APPROVALS		TITLE: BACKLINE 250 POWER AMP	
INIT	DATE	REV	DRAWING NO:
DESIGNED: R.A.G.	12/3/00	B	406-0108-A
DRAWN: R.A.G.	3/04/02		PART NO: 206-0108-A
ELEC:			
MECH:		COMPANY:	GALLIEN-KRUEGER
Q/A:		FILENAME:	60108A
RELEASED:

Customer Name:	Gallien-Krueger	Current Rev #:	A00	New ECO Rev #:	A01
Model:	Backline 250 / Backline 115			Page:	1 Of: 1
Assembly Description:	Power Amp. Module	Originator:	R. Gallien		
Assembly Numbers:	206-0108-A	Approved by:			
		Effective Date:	2/26/2002		
Effective		Document Update		Date	Initials
<input checked="" type="checkbox"/>	All in Process	<input checked="" type="checkbox"/>	Artwork		
<input checked="" type="checkbox"/>	All in Service	<input checked="" type="checkbox"/>	Assembly Dwg.		
<input checked="" type="checkbox"/>	All in Stock	<input type="checkbox"/>	Board Artwork		
Beginning Serial Number:		<input checked="" type="checkbox"/>	BOM		RAG
Reason For Change		<input type="checkbox"/>	Control Form		
Update fuse from F2.5A to T2.5A. Time lag is required to withstand inrush at turn on.		<input type="checkbox"/>	Costing		
Add new fuse label to power amp marked: 100-120V:T2.5A/250V Semko For 100 and 120V models.		<input type="checkbox"/>	Fab Drawing

TI

TITLE: BACKLINE 115 POWER AMP

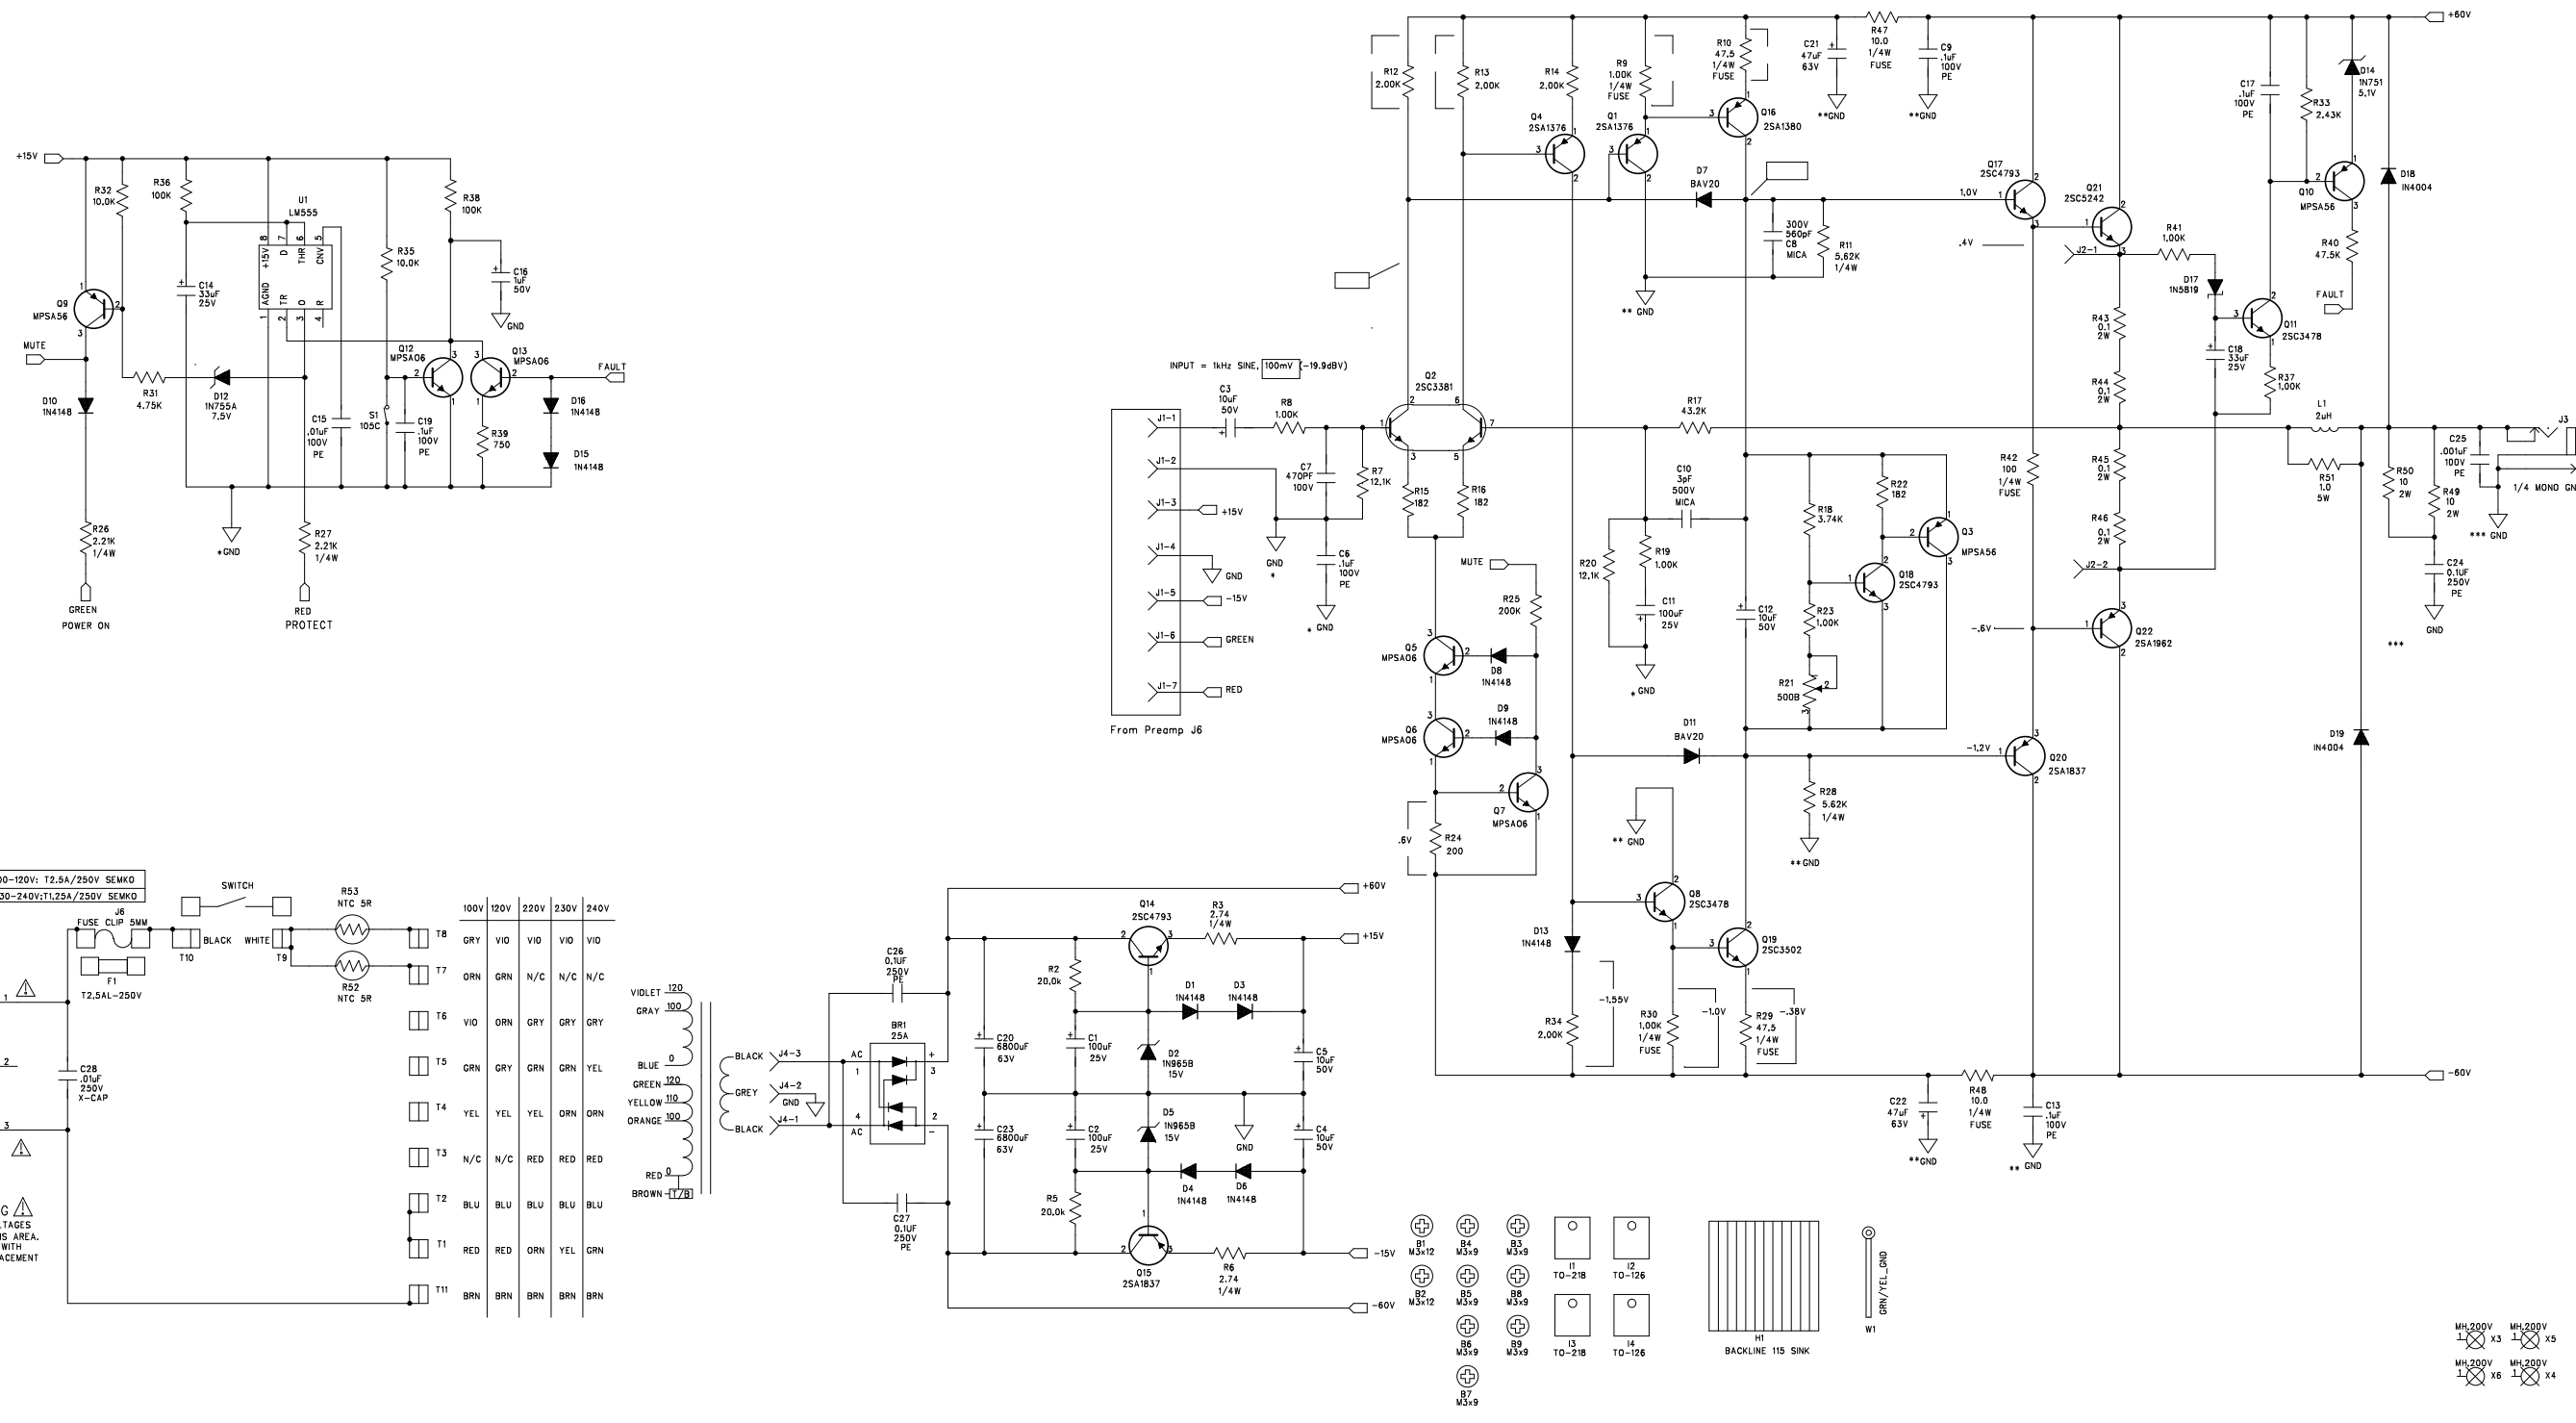
NOTES FOR REV A1:
 1. ADDED THERMISTORS R52 & 53.
 2. ADDED 240V SUPPLY TABLE.

figure 2a

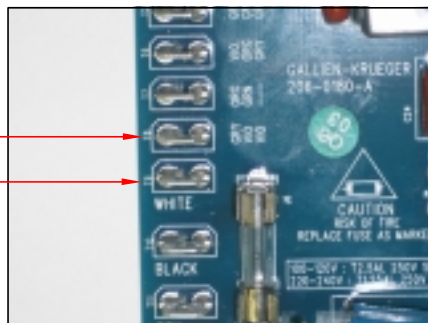
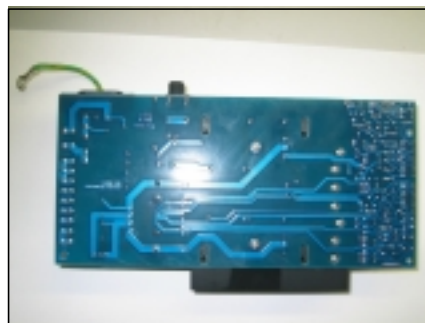
This document is generated to address fuse failure due to excessive inrush current during turn on. It is applicable to Backline 115 and Backline 250 power amp boards with part number 206-0180-A.

To correct the problem, a thermistor with part number 022-3010-0 is soldered in series with the primary side of the transformer.

Locate T8 and T9 on the power amp board (figure 2a). Turn the power amp board over as per figure 2b.

Locate T8 and T9 on the bottom/solder side of the board (figure 3a). Cut the trace between T8 and T9 as shown in figure 3b.

figure 4

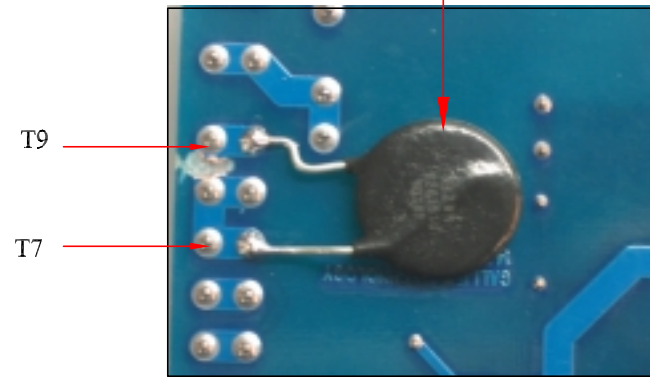
Solder one lead of Thermistor (022-3010-0) to T9 and the other to T7, as shown in figure 4.

Note: Make sure that no portion or part of the thermistor is touching any terminal on the board except terminals T7 and T9.

Thermistor NTC 8 ohms, 3 ampere
Manufacturing Part #: 08SP003M
GK Part #: 022-3010-0

figure 4

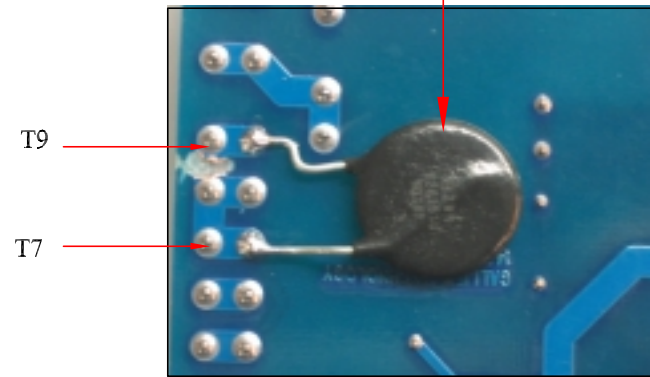
Solder one lead of Thermistor (022-3015-0) to T9 and the other to T7, as shown in figure 4.

Note: Make sure that no portion or part of the thermistor is touching any terminal on the board except terminals T7 and T9.

Thermistor NTC 8 ohms, 3 ampere
Manufacturing Part #: 08SP008M
GK Part #: 022-3015-0
